AGENDA

CITY OF TAYLOR, TEXAS

PLANNING AND ZONING COMMISSION MEETING

October 11, 2022, 6:00 P.M.

**TYPICAL UTILITY AND
STREET SECTION ASSIGNMENT
LOCAL STREET**

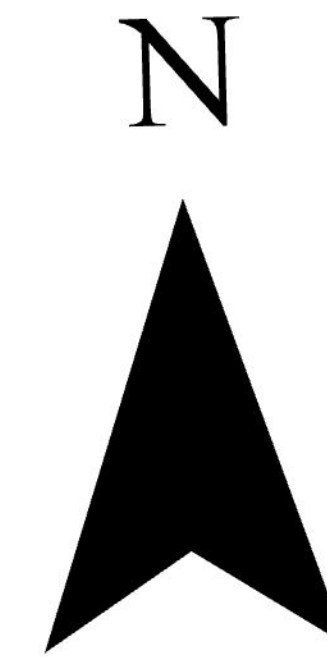
1. Submit a street lighting & photometric plan (Sec. 2.8.13, Subdivision Ordinance & Sec. 5.4.5, Zoning Ordinance).
2. The street section and utility assignments used do not reflect the currently adopted street section within the Comprehensive Plan. The streets within this subdivision would be Yield Streets (sections located on p. 111 within the Envision Taylor Comprehensive Plan). However, the City Engineer has modified this section to exclude bulb-outs and accommodate a 50' ROW. This modified street section shall be utilized for this project and all pertinent sheets must be updated accordingly. **Refer to Appendix A - Planning Attachment** (Sec. 1.3, Zoning Ordinance).
